HISTORIC AND DESIGN REVIEW COMMISSION

Agenda Item No: 5

HDRC CASE NO: 2016-148
ADDRESS: 803 S ST MARYS
LEGAL DESCRIPTION: NCB 738 BLK 1 LOT N IRR 120 OF 1 OR A1,S IRR 51.6 OF N 117 OF 1&2,NE TRI OF 6 OR A7
ZONING: C2 IDZ H
CITY COUNCIL DIST.: 1
DISTRICT: King William Historic District
APPLICANT: Jim Poteet
OWNER: Raul Villareal
TYPE OF WORK: Exterior Alterations
REQUEST:

EXTERIOR ELEVATION: AWNING & SIGNAGE

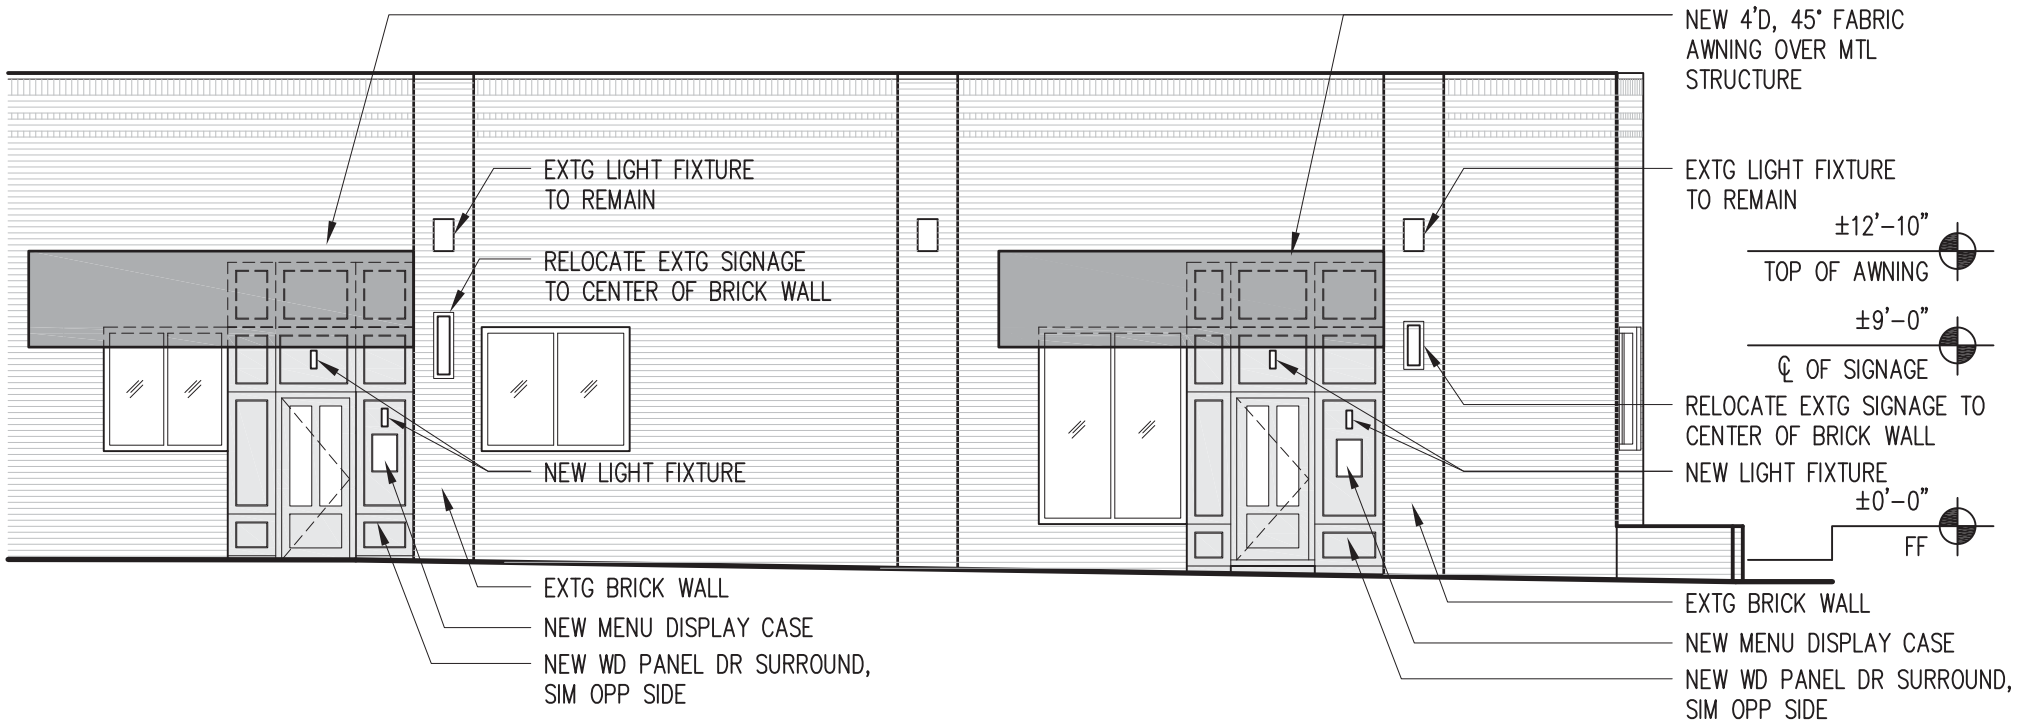
- c. The proposed canopies are scaled appropriately for their locations. As submitted, the canopies are offset to the right side of each structural bay. Extending the canopies to the full width of each structural bay of the proposed installations would follow traditional installation patterns and would be more consistent with the Guidelines for Exterior Maintenance and Alterations 11.B.ii.

1-3. Staff recommends approval with the stipulation that the proposed awnings are extended to the full width of the structural bays in which they are placed based on finding c.
